## 4700 Brooklyn Ave NE

MIXED-USE STUDENT HOUSING  
DESIGN REVIEW BOARD RECOMMENDATION MEETING

DPD PROJECT NO.:  
3020236

MEETING DATE:  
March 14, 2016

# Site Plan

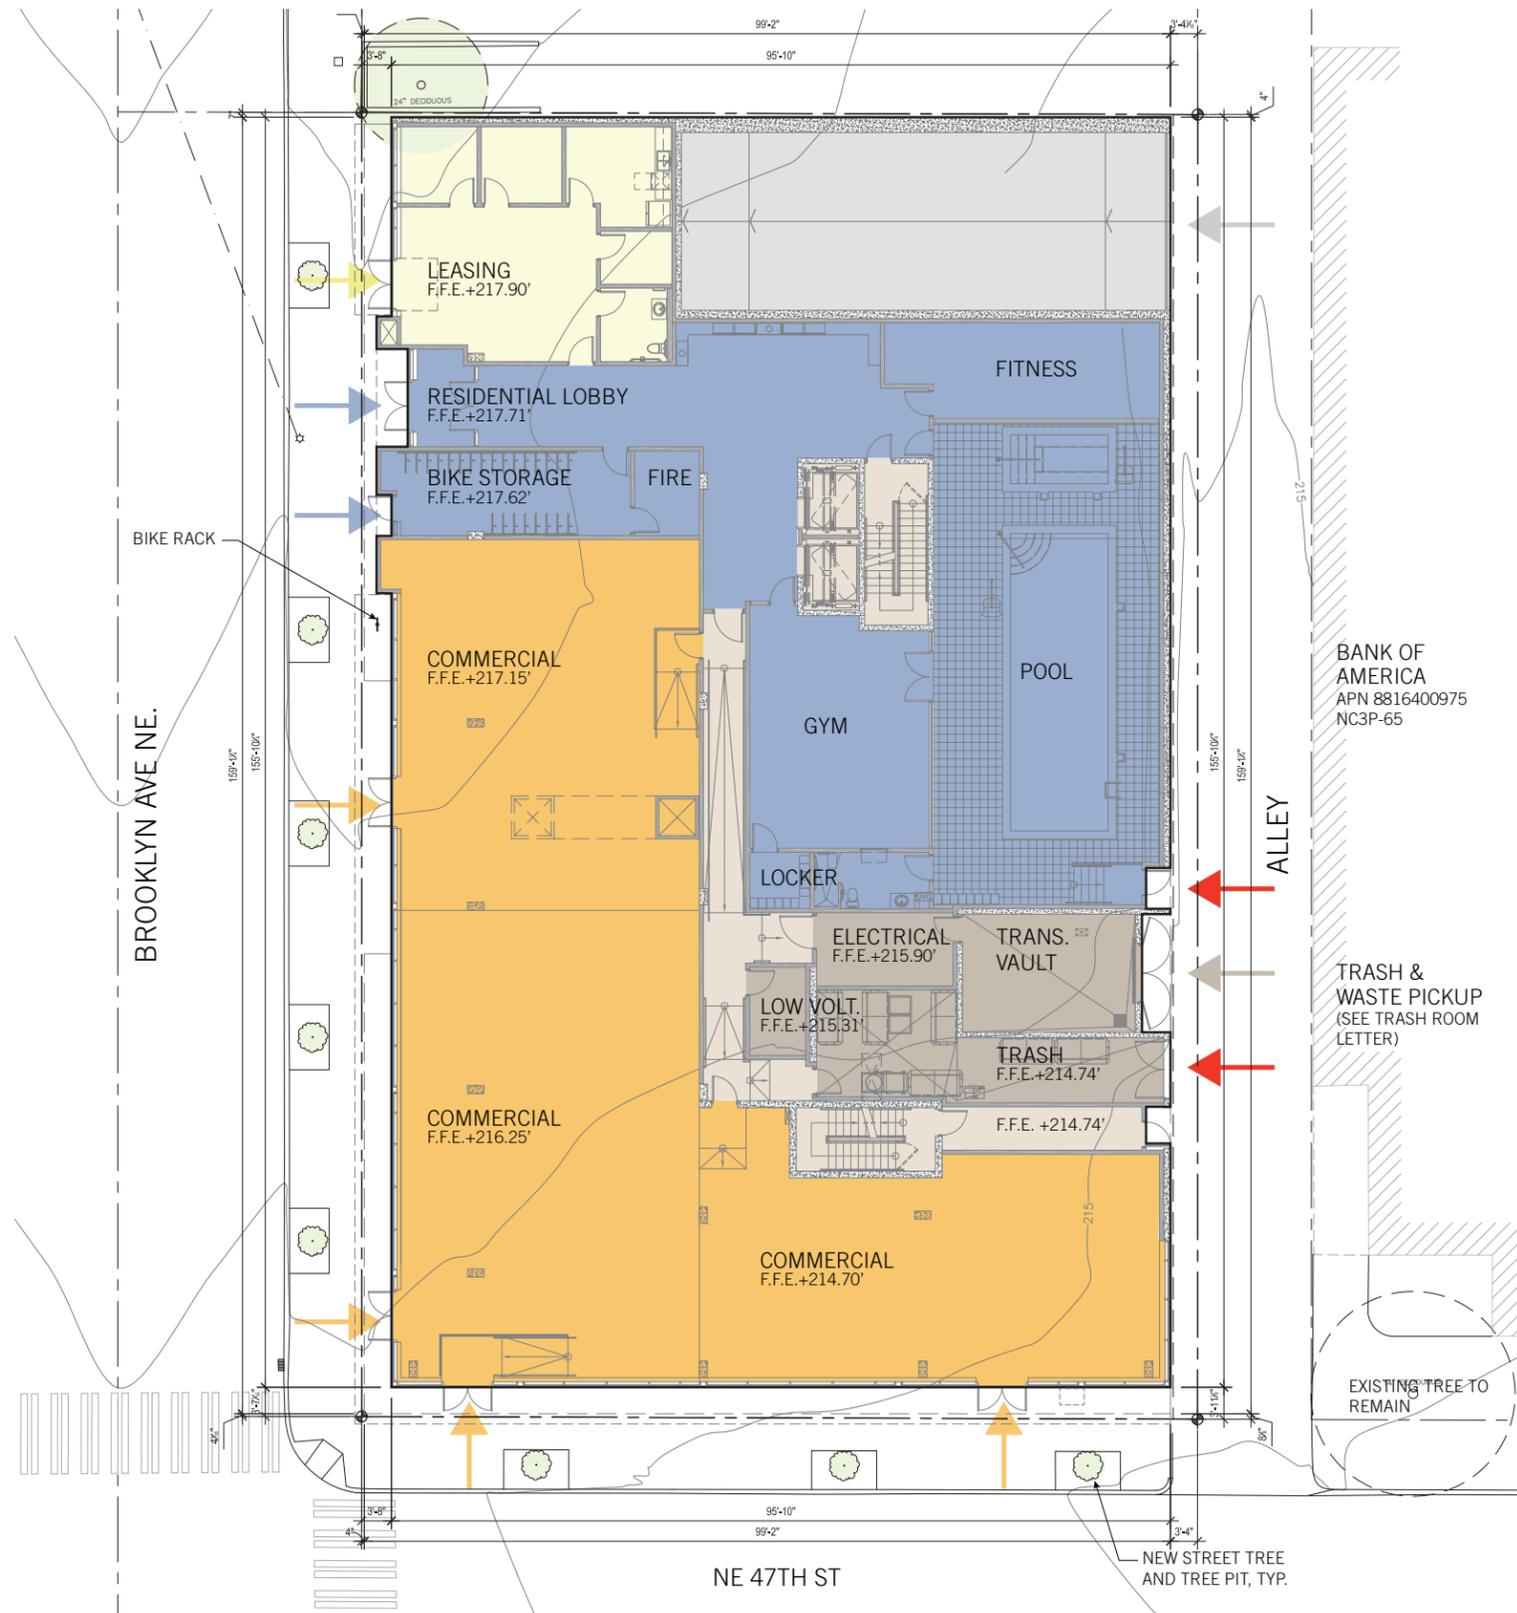
<p>Site Plan</p> <ul style="list-style-type: none"> <li>Please color code the composite site plan to indicate proposed uses.</li> <li>Include open spaces, street trees, and any landscaping areas.</li> </ul>	<p>Site Plan</p> <ul style="list-style-type: none"> <li>The site plan has been updated to show the proposed uses and is color coded to match the areas represented in the packet on the plan sets (pages 22-25). Also, the landscaped areas and street trees are being shown on this site plan as well as new pages (27-29) showing the landscape design of the ground, level 2 courtyard and roof deck.</li> </ul>	<p>See Site Plan, Page 10</p>
<p>Massing Alternatives &amp; Architectural Concept</p> <ul style="list-style-type: none"> <li>Provide street-level perspectives.</li> <li>Indicate pedestrian and vehicular entries (arrows).</li> <li>Include three-dimensional sketches/studies at street level to demonstrate the intended character.</li> <li>Include images that will inform the design development as it progresses. Clearly identify and note each reference. (roof types, fenestration patterns, trim, corner elements, etc.)</li> </ul>	<p>Massing Alternatives &amp; Architectural Concept</p> <ul style="list-style-type: none"> <li>Images of street level perspectives for the preferred scheme have been added after the plan sets in the packet.</li> <li>Entry arrows at all residential, commercial and vehicular access points on the ground level are on site plan (pg. 10)</li> </ul>	<p>See Renderings, Page 35-42</p>
